SUBJECT: Forwards responses to request for addl info re PRA for MHS,  
 per 821122 request.

Subject: Palo Verde Nuclear Generating Station  
(PVNGS) Docket Nos. STN-50-528/529/530  
File: 83-056-026; G.1.01.10

PROBABILISTIC RISK ASSESSMENT (PRA) STUDY  
PALO VERDE NUCLEAR GENERATING STATION

RESPONSE TO REQUEST FOR ADDITIONAL INFORMATION

Figure II-1

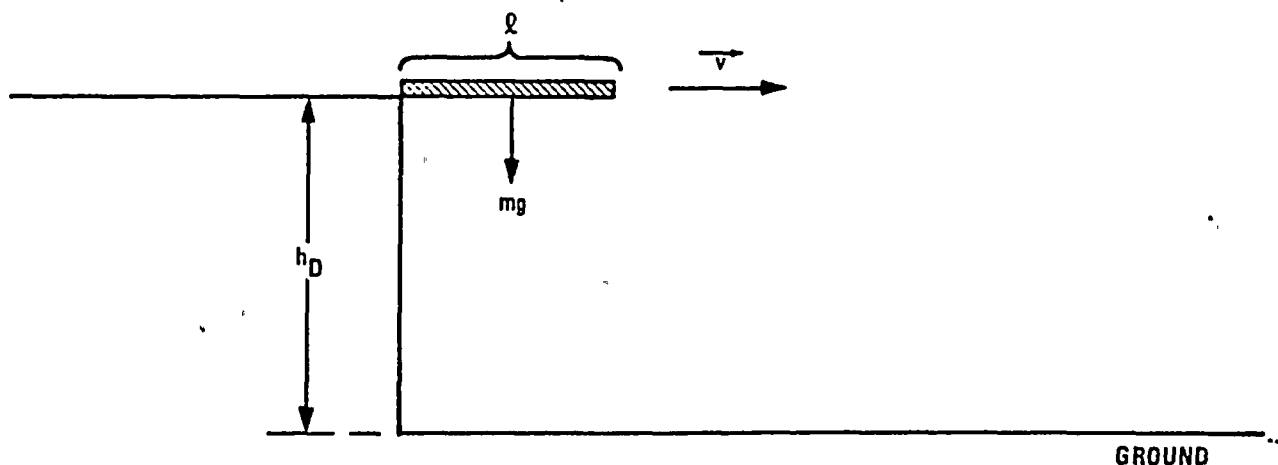
6. It is stated in the PRA study that the tornado missile problem has three time scales:  $T_1 = \ell/w$ ,  $T_2 = (\ell/g)^{\frac{1}{2}}$ ,  $T_3 = R/w$ , where  $\ell$  = length of missile,  $w$  = maximum velocity of tornado,  $R$  = characteristic size of the tornado "footprint", and  $g$  = acceleration of gravity (p. B-4). An explanation is needed with regard to the characterization of  $T_2$  in the study as a typical rotation time. Also, the validity of the inequality  $T_2 < T_3$  (in Eq. B-11) is not clear and should be explained. (For example, if  $R \cong 150$  ft and  $w \cong 300$  ft/sec,  $T_3 = 0.5$  sec, while for  $\ell \cong 20$  ft,  $T_2 \cong (20/32.2)^{\frac{1}{2}} = 0.8$  sec.)

Scenario 1. The horizontal injection of a missile

Consider a potential missile initially located at some elevation. At some moment the aerodynamic force can overcome the restraint and move the potential missile to the brink of a storage area. The moment created by aerodynamic force and restraint will orient the missile in downwind direction. The very moment of horizontal injection is shown in Figure II-1.

$$T_2 = \sqrt{\frac{2\pi}{6}} \cdot \frac{\ell}{g} \approx \sqrt{\frac{\ell}{g}}$$

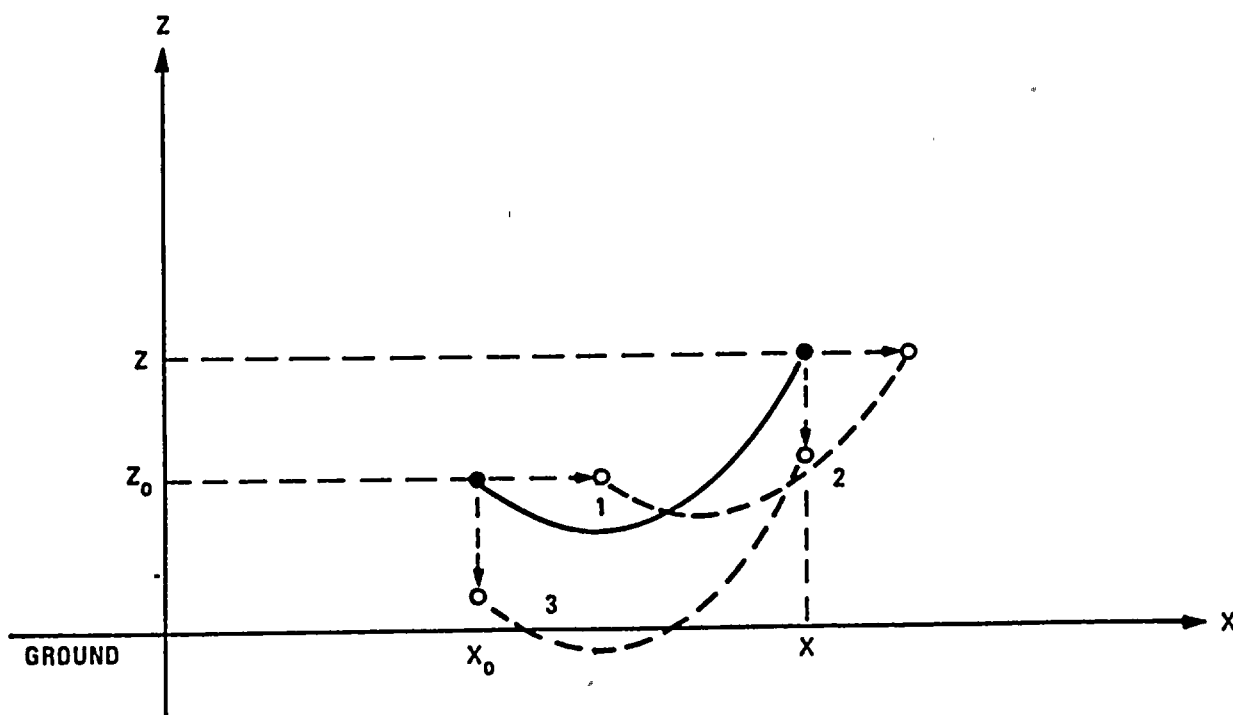
11. A detailed explanation is required of the steps leading from Eq. D-31 to Eq. D-32.

In our case it is true for all translations except of translation in the vertical direction (see Figure IV-1). For example, the virtual trajectory 1 connecting points  $(x_0, z_0)$  and  $(x, z)$  will correspond to the virtual trajectory 2 after parallel translation in the x-direction.

In the case of parallel translation in the z-direction, the corresponding trajectory 3 could intersect the ground and will not contribute into sum (IV-2) any more.

Therefore, the available set of trajectories  $\Gamma(z_0)$  is a function of the missile source elevation  $z_0$ .
